WAIVER/CONCESSION

1. DOCUMENT IDENTIFICATION		1.1. Identification of customer: Rolls-Royce Canada Limited		Supplier #:		1.3. Document reference number Customer #: 210256950		1.5. Category: "GE-3656", CAT 2

2.1. Model of product/program: I TRENT		2.2. Part number: TRN14806		Drawing Issue:		2.4. Part Serial Number/Batch/Effectivity Number/Lot Number: (see box 3)		2.5. Quantity: 1	
Contract Number:		2.3. Part Description: CASE, INLET, ASSY OF		2.6. Product Number:		2.7. Work/Purchase Order Number:		2.8. Assembly Serial Number:

C10C 2601 1100 - 29

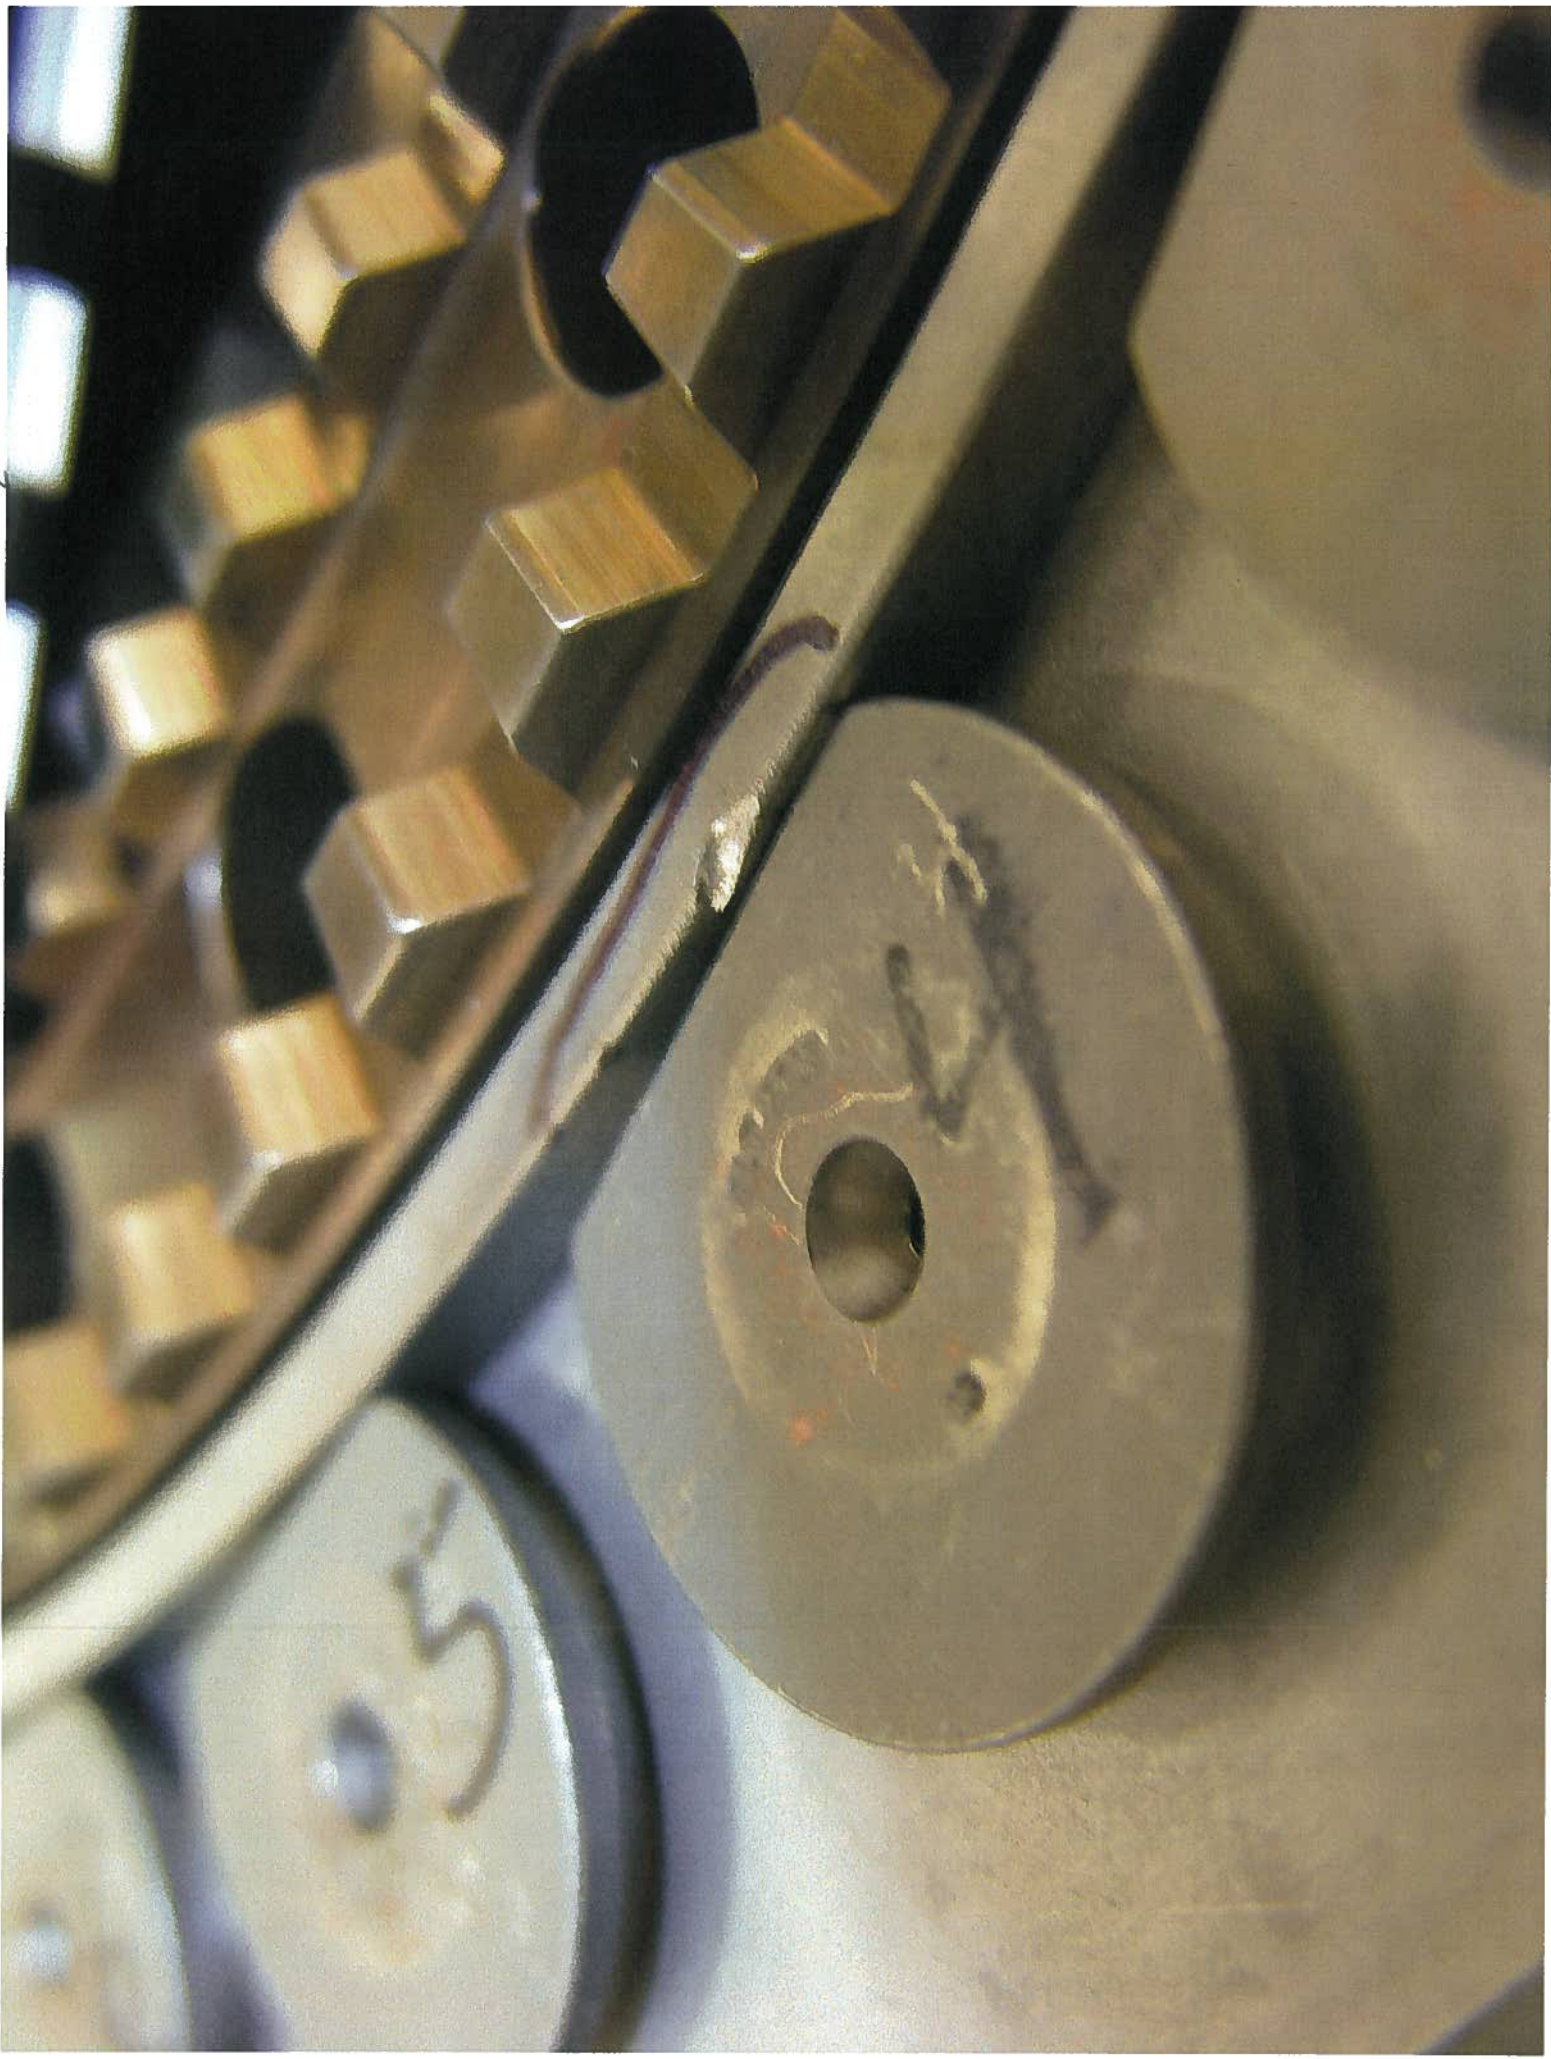
3. DESCRIPTION OF NONCONFORMITY		3.1. Detailed Description of the nonconformity							
IRENT ESN 056 Module08. Reference notification #210240551.		<p>During torque tightening of taper bolts, 3-off bolt head created nicks at adjacent abutment face corner. Front face of disc. Refer to attached pictures.</p> <p>Approx measurements: Between 0.082" long by 0.032" deep to 0.188" long by 0.038" deep</p> <p>Request to repair to remove evidence (dress out damage) as per EFRS6627 EFRS6625.</p> <p>Previous Submissions of a similar nature: Previous Submissions to actual item:</p>

FIGURE 1

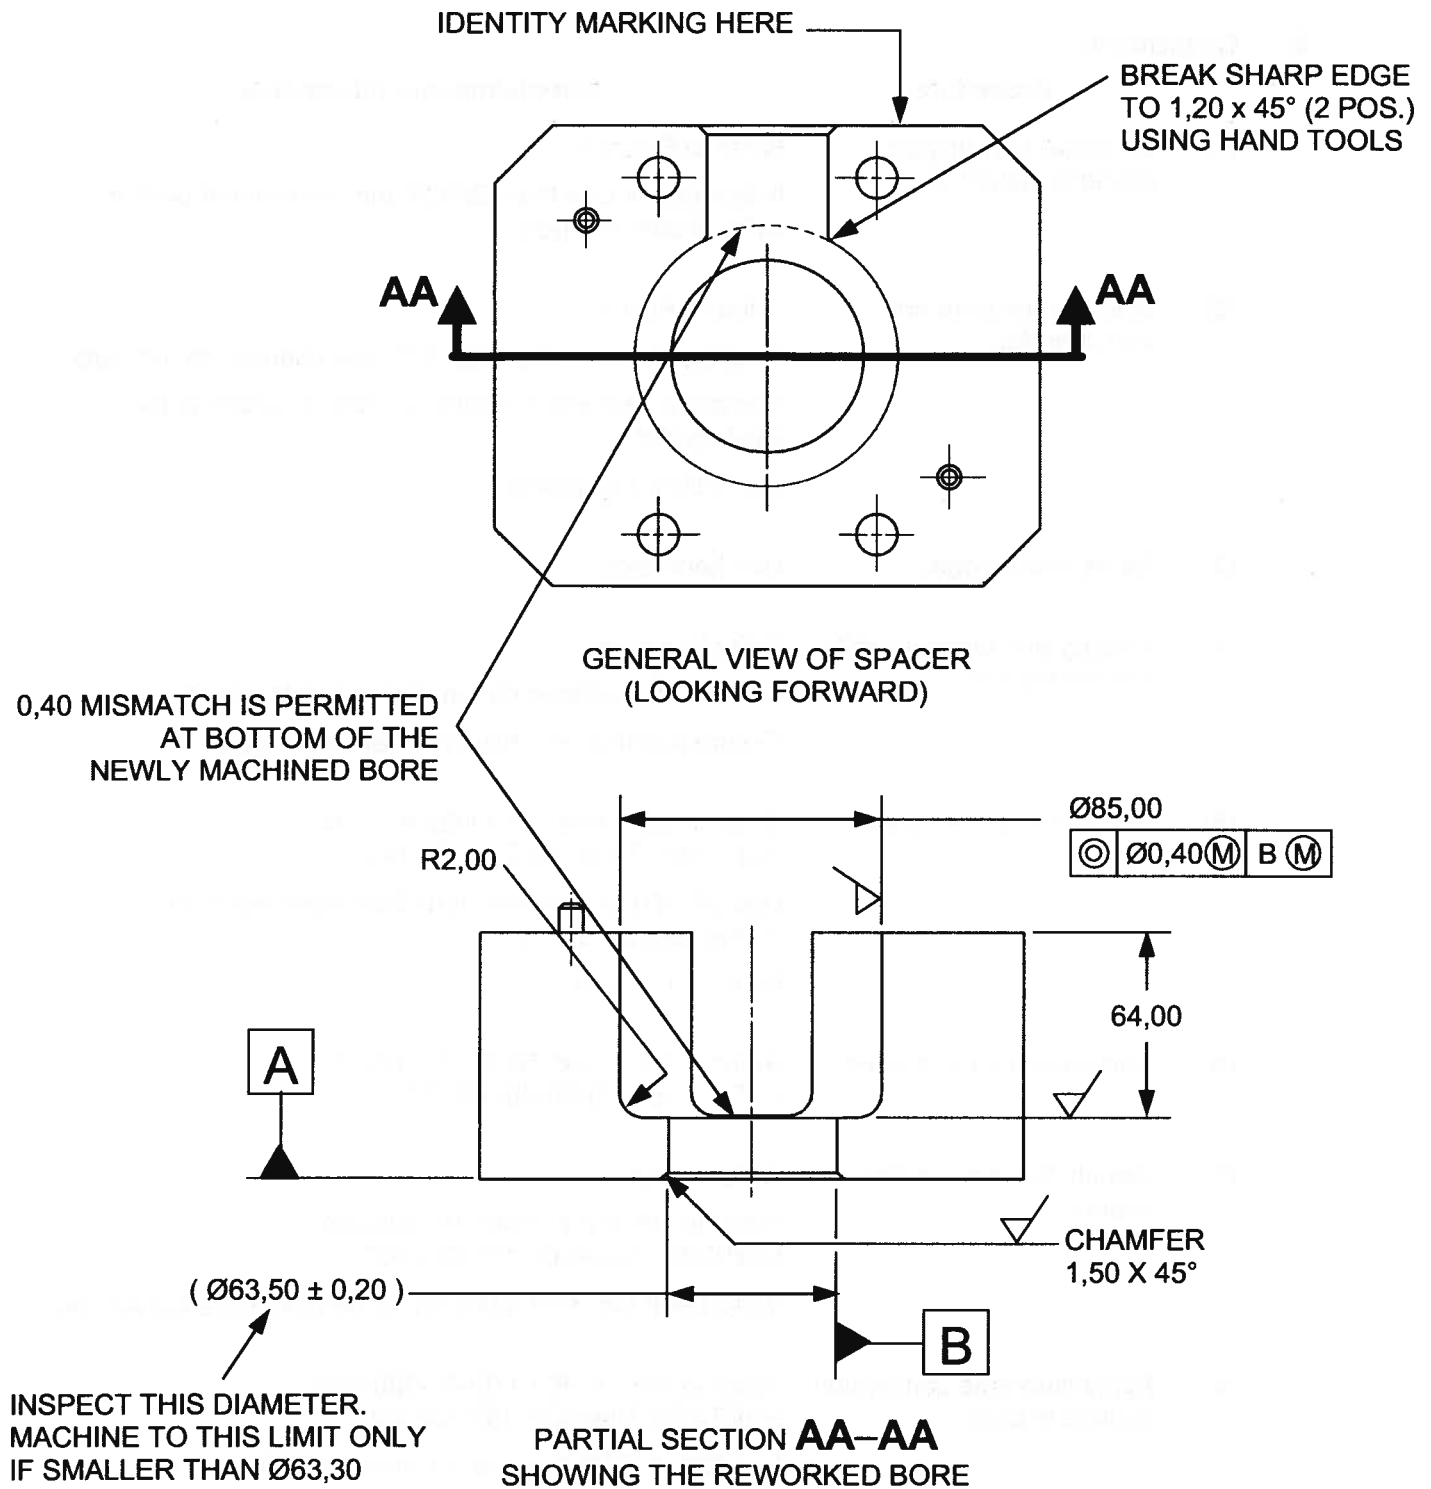
3. DESCRIPTION OF NONCONFORMITY		5. DISPOSITION OF NONCONFORMITY							
ESN 062 Z1# 210285761		Life Data:							
Unable to fully retract the LVDT bracket TRN101022, which is located on the LPBOV Actuators, due to the fact that the inner diameter of the Actuator support bracket TRN101824 and spacer TRN101823 is smaller than the outer diameter of the LVDT bracket TRN101022.		5.1. MRB/Design Decision: Follow the attached rework scheme, until the C-sheet and MOD TRI-0648 have been issued. CAT 2, Non-delegated. Mark concession "CAT 2. GE-3795" next to part number. Record concession "CAT 2. GE-3795" into engine LogBook. At the earliest opportunity, Modification TRI-0648 is to be implemented.							
The LVDT bracket TRN101022 outer diameter is 80 mm.									
The support bracket (TRN101824) inner diameter is 63.50 mm.									
Request engineering decision.									
Previous Submissions of a similar nature:		Previous Submissions to actual item:

Procedure	Supplementary Information
(1) Dimensionally inspect diameter datum -B-	Refer to Figure 1. If diameter is less than Ø63,30 mm, machine it back to limits shown on figure.

(2) Machine the bore and add chamfer.	Refer to Figure 1. Machine the bore diameter and new chamfer as indicated. Use extra care when machining bore adjacent to the existing slot. Use milling equipment.

(3) Break sharp edges	Use hand tools.
(4) Visually and dimensionally inspect the part	Refer to Figure 1. Ensure all machined dimensions are within limits. Ensure locating pins have not been damaged.

(6) Degrease the component.	Refer to OP TASK 70-00-00-100-101 or OP TASK 70-00-00-100-102.
(7) Identify the concession rework.	Refer to Figure 1. Refer to OP TASK 70-00-00-300-363, SUBTASK 70-00-00-180-363-027. Vibro-peen GE-3795 adjacent to part identification number.

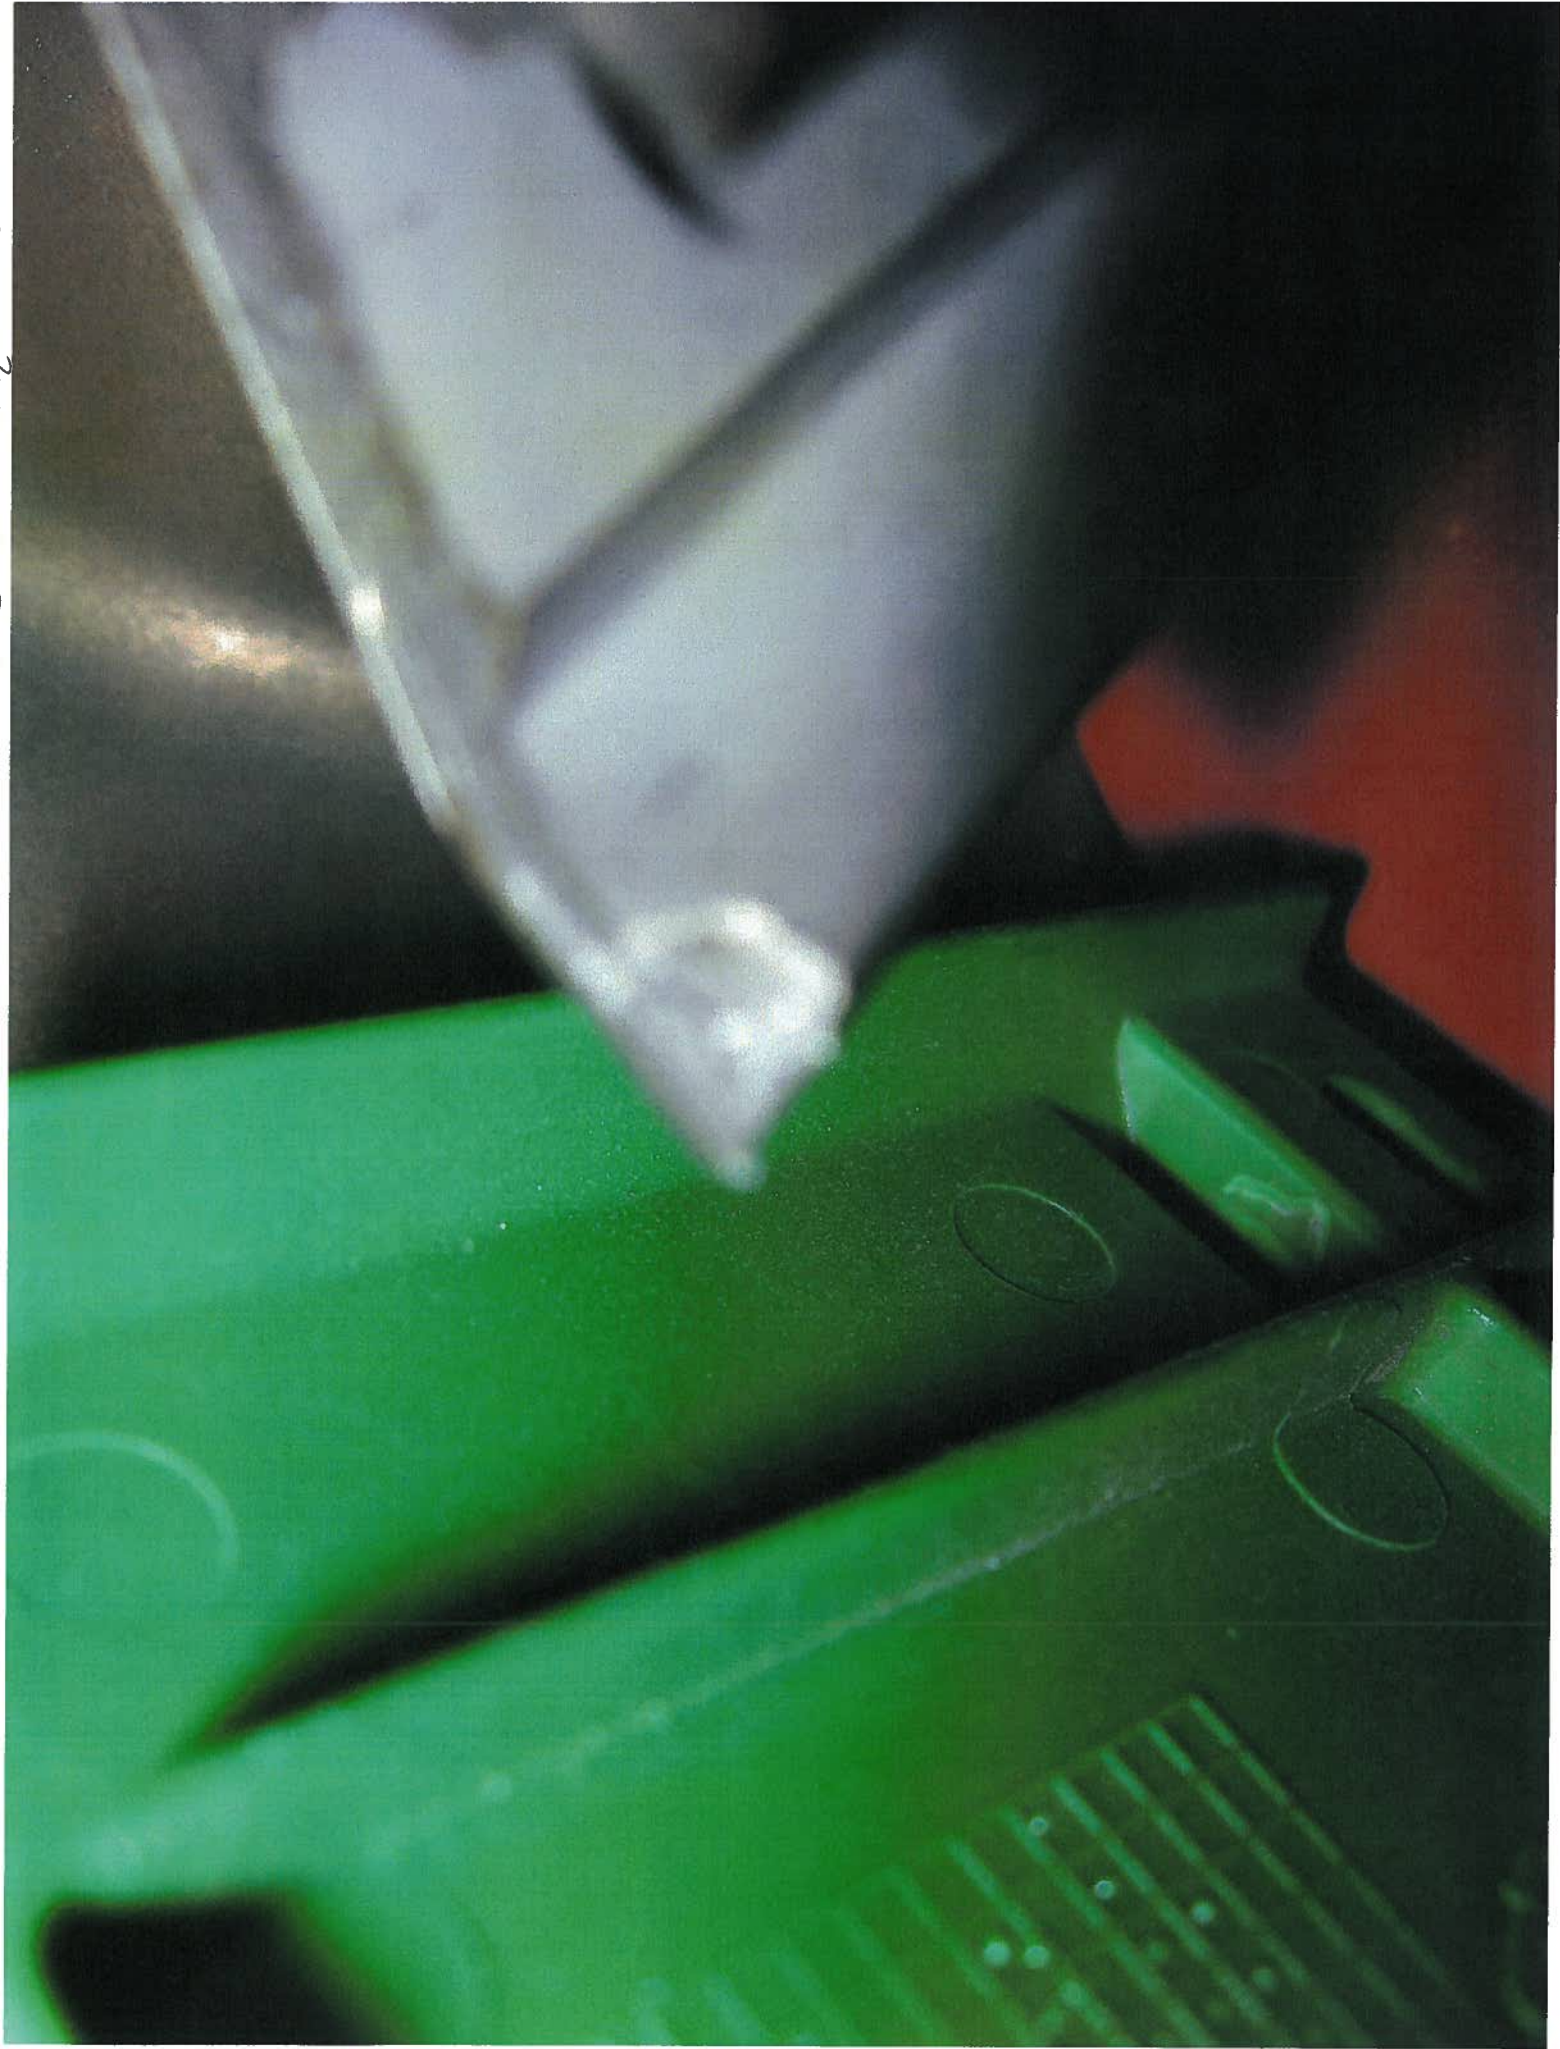
3. DESCRIPTION OF NONCONFORMITY		5. DISPOSITION OF NONCONFORMITY							
ENG 057 QN 210244698 1 OFF NGV DAMAGED DURING FIT AT SEALING STRIP END LOCATION (DAMAGE AND CHIP) .220" x .200" LENGTH AS PER BHS M5-10-00 B-01 Request to polish to remove damage and crack test as per TSD594J op 210.		5.1. MRB/Design Decision: ACCEPTABLE FOLLOWING REPAIR. CAT 2. MARK "Cat 2, GE-3610" NEXT TO PART NUMBER.							
Previous Submissions of a similar nature: 1008759		Previous Submissions to actual item:		Quality Decision:
